# SERVICE LETTER

No. 329A

Piper Aircraft Corporation  
(Supersedes Service Letter No. 329)

**SUBJECT:** Inspection of Oil Cooler Lines, Oil Cooler Line Securing Clamps and Oil Cooler Line Attachments to Oil Radiator

SERVICE LETTER 329 A

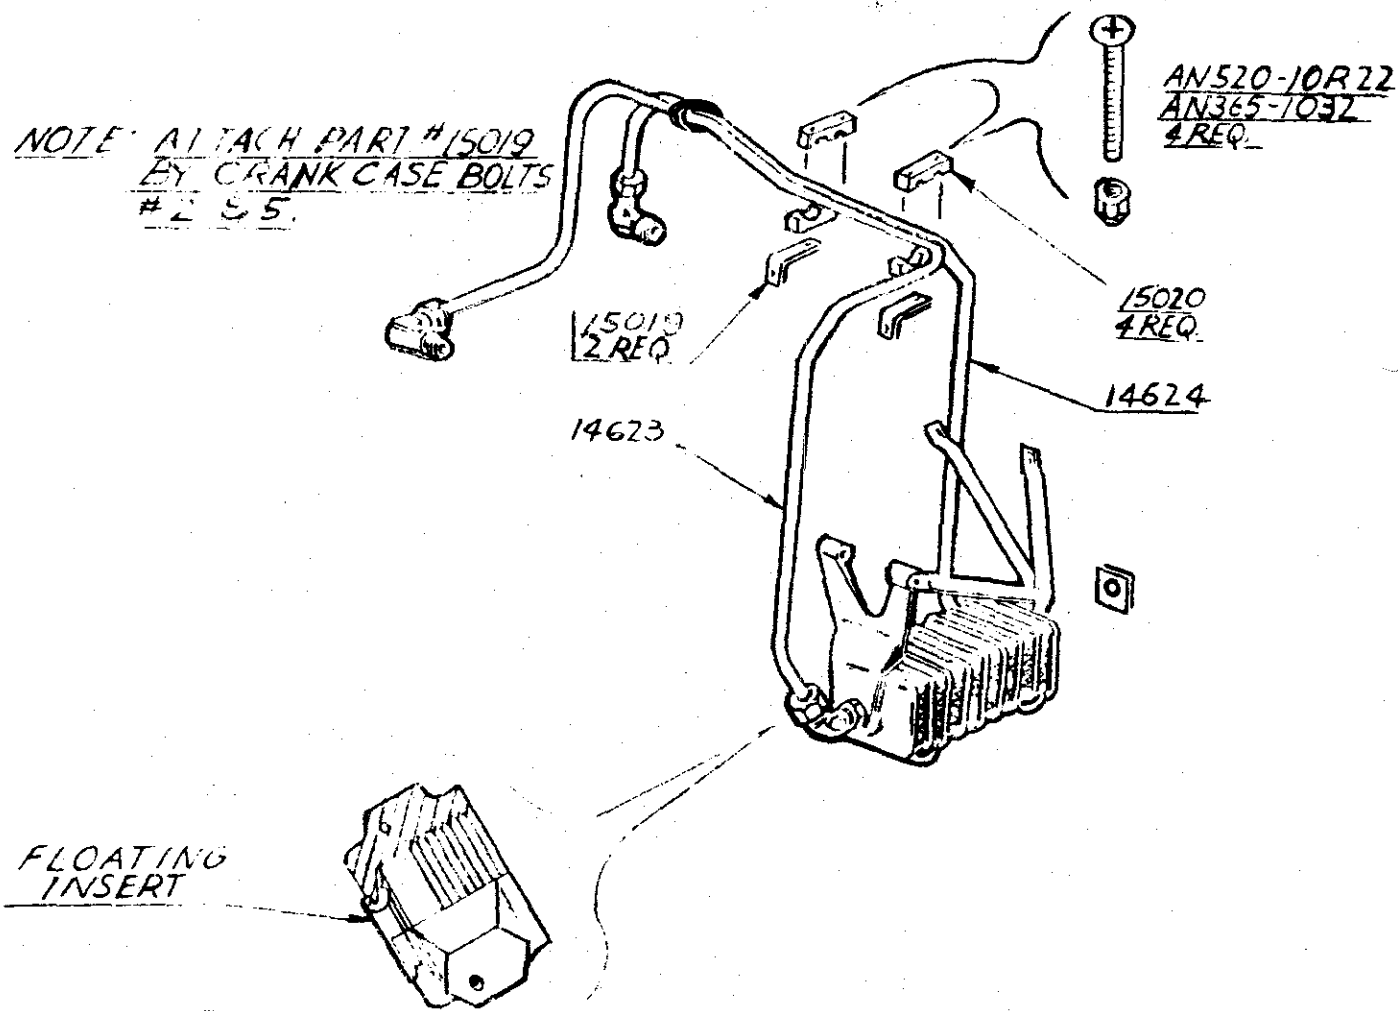
Serial Nos. 22-6760, 22-6761, 22-6763 and up were equipped with improved oil line retaining blocks, part number 15020-00, and brackets, part number 15019-00. These will aid in further reducing the effects of misalignment and vibration. We recommend the installation of the new type retaining block and bracket on Serial Nos. 22-3886 to 22-6759 inclusive and 22-6762. See Sketch on reverse side.

NOTE:  
OIL COMPRESSION NUT SEAL  
RING ALL OVER BEFORE  
TIGHTENING. TIGHTEN TO  
125 IN. LBS. THEN SAFETY.
